**Knott Landfill – Cell 7 Construction Project
Deschutes County Department of Solid Waste
Deschutes County, Oregon**

ADDENDUM NO. 1

Date Issued: October 13, 2017

CELL 7
CELL 5 & 6 PUMP STATION MODIFICATIONS

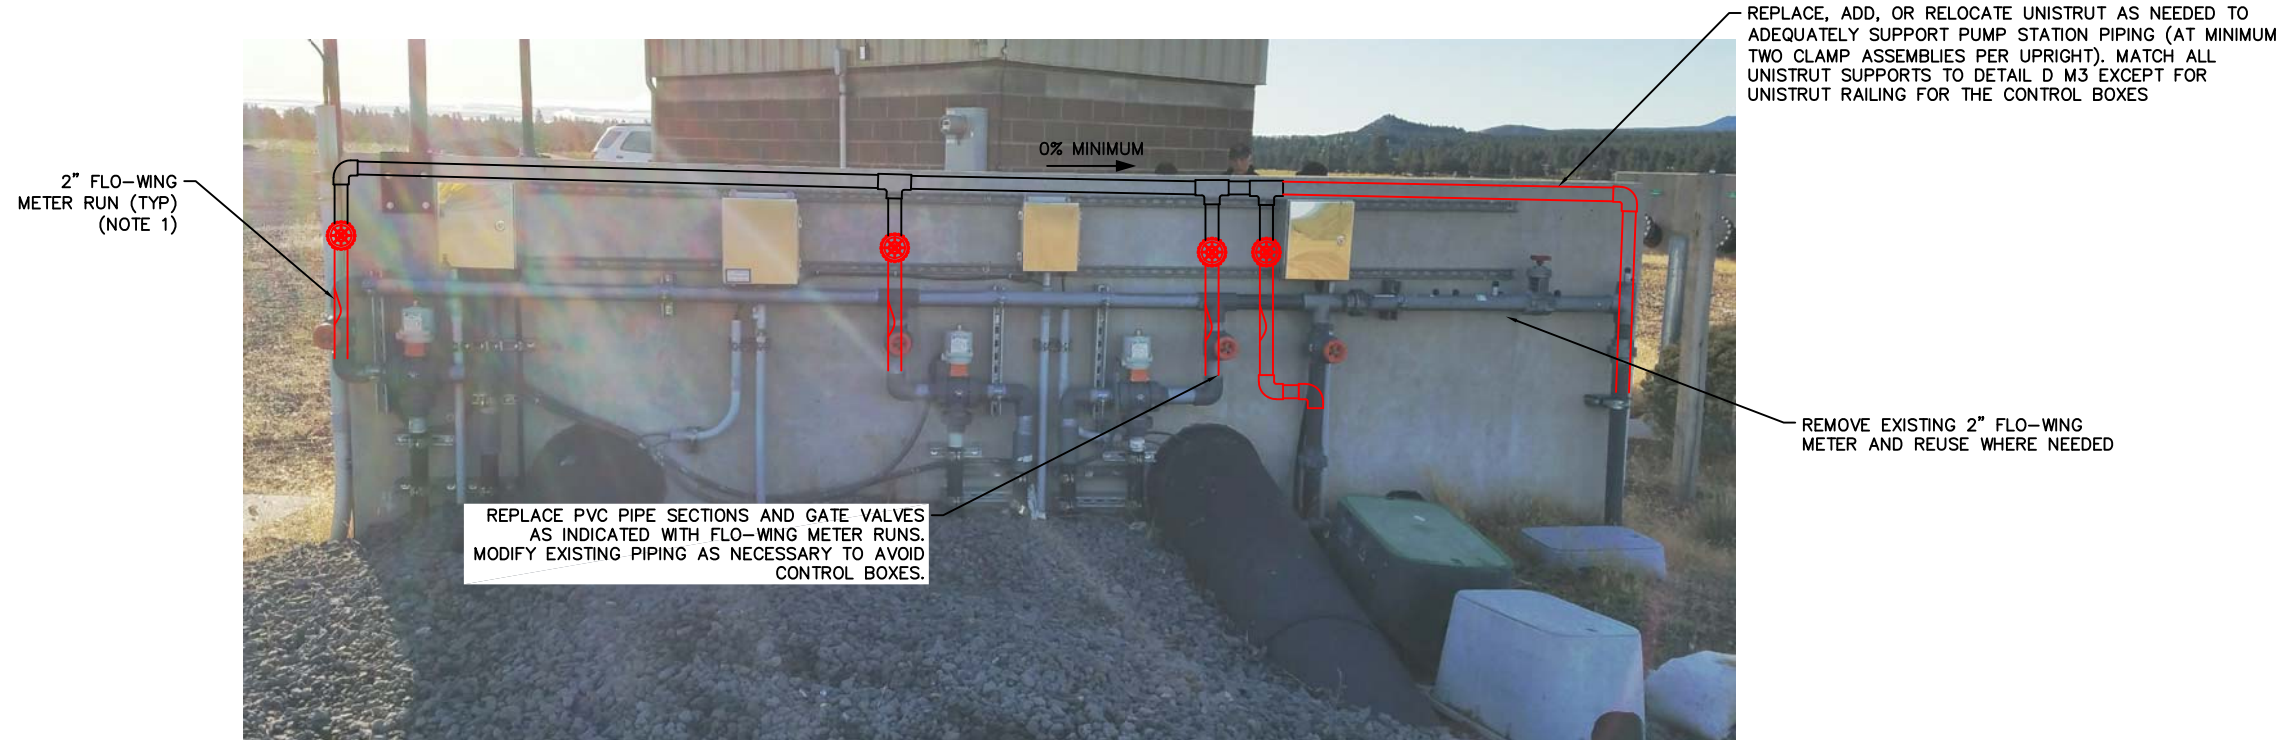
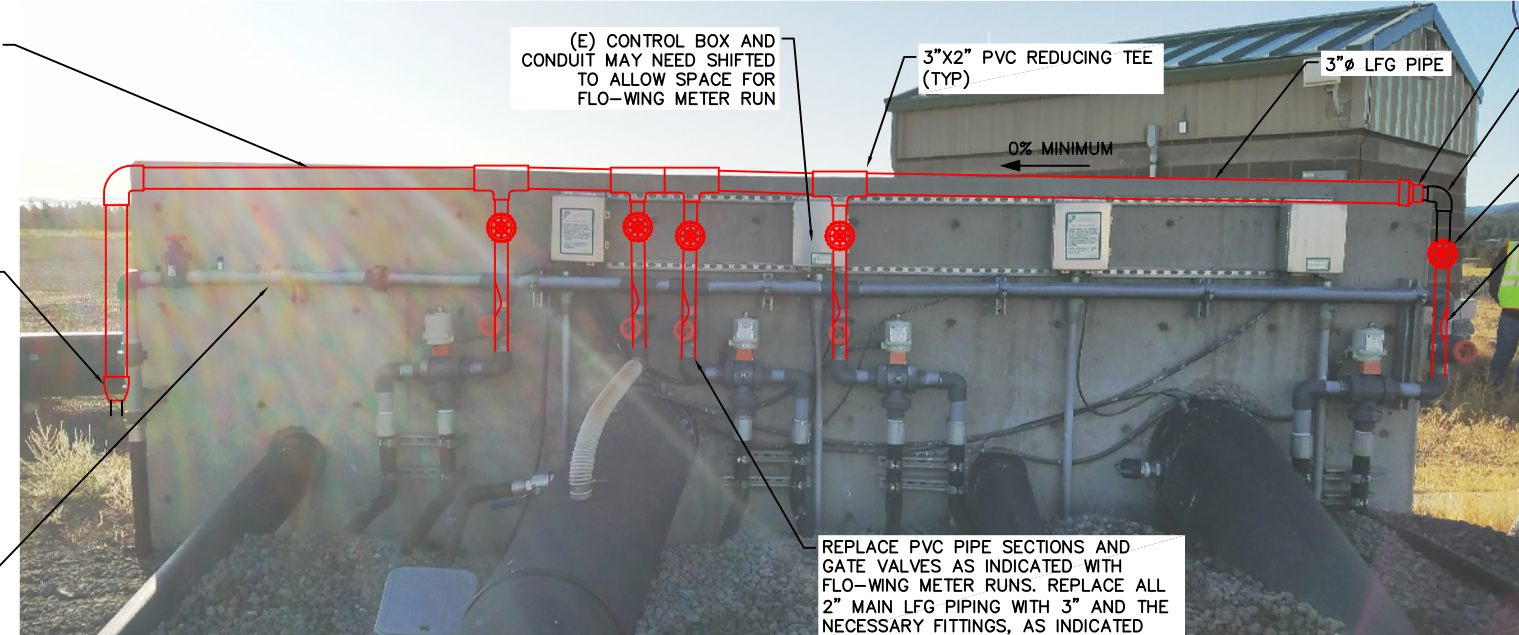
REPLACE, ADD, OR RELOCATE UNISTRUT AS NEEDED TO ADEQUATELY SUPPORT PUMP STATION PIPING (AT MINIMUM TWO CLAMP ASSEMBLIES PER UPRIGHT). MATCH ALL UNISTRUT SUPPORTS TO DETAIL D M3 EXCEPT FOR UNISTRUT RAILING FOR THE CONTROL BOXES

1. CUT FLO-WING METER RUNS DOWN IF NECESSARY; 6" OF PIPE MUST BE MAINTAINED UP AND DOWNSTREAM OF METERING PORTS.
2. ALL PIPE MODIFICATIONS SHOWN IN RED.
